**PLANNING AND ZONING
LAND USE REVIEW
Town of Thunderbolt**

Request: Request to rezone via map amendment 1 parcel lot of record from One-Family Residential [R-1] to Two-Family Residential [R-2] in the vicinity of Whatley Avenue and Shell Road.

Location: 2811 Whatley Avenue

Parcel ID#: 30003 03011

A BOUNDARY RETRACEMENT SURVEY OF
**SOUTHERN PORTION OF LOT 10, SUBDIVISION OF THE
 FORMER MERCHANTS & MECHANICS LAND CO. PROPERTY**
 TOWN OF THUNDERBOLT, CHATHAM COUNTY, GEORGIA

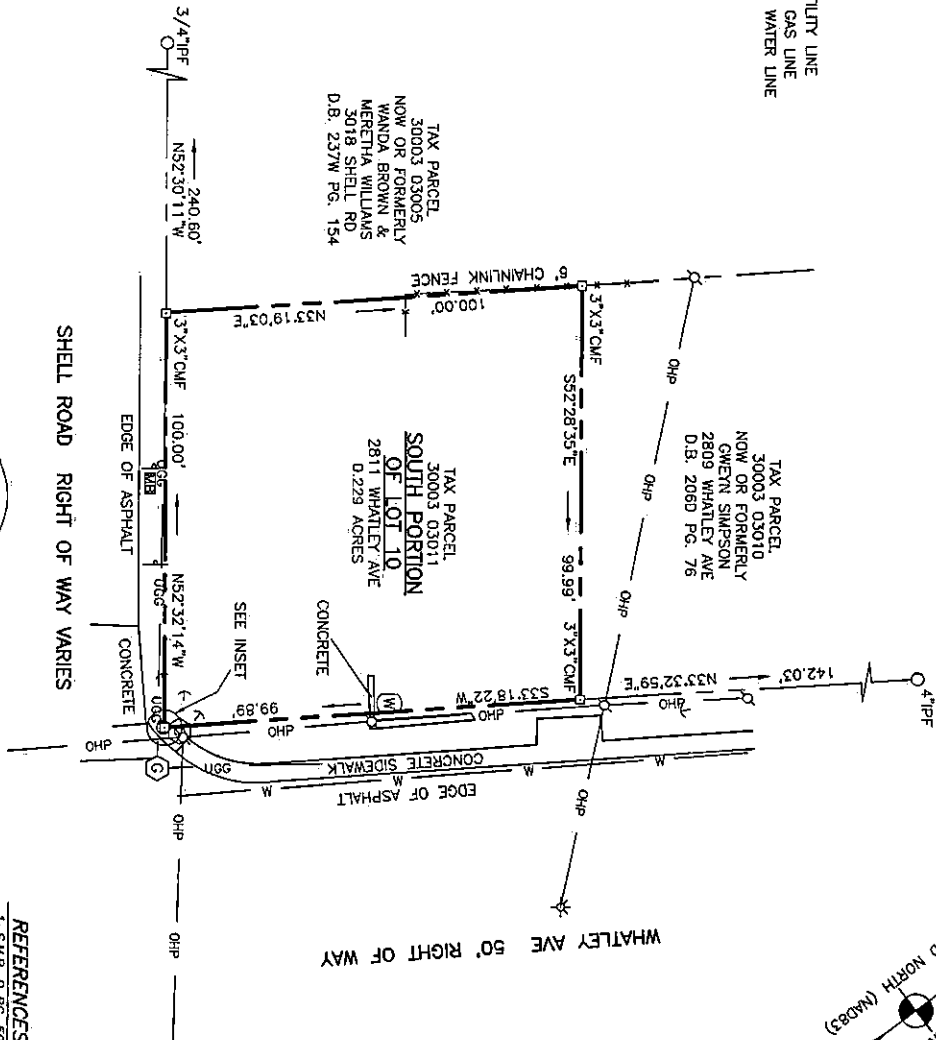
Site Plan: Summary of Review finds that applicants' proposal does meet the maximum gross density allowable; and it is within the size and scale of the Development Standards Table.

Applicant must demonstrate the front forward facing side of the street corner of site plan.

Minimum parking requirements are 2 spaces per unit; Applicant must specify where on the site plan necessary parking spaces are located. Driveways must be separated a minimum 20 feet.

Any condition imposed on the side yard of the corner lot will update the applicant's Maximum Buildable Area.

**SETBACKS: 25 FEET FRONT; 7 INTERIOR SIDE; 25 FEET BACK;
15 FEET ROW SIDE MIN – 25 FEET ROW CORNER MAX
BUILDING AREA WIDTH: MAXIMUM 78 FEET WIDE TWO UNITS
PARKING: TWO (2) PARKING SPACES PER UNIT
DRIVEWAYS: TWO (2) SEPARATE DRIVEWAYS 20 FEET APART**
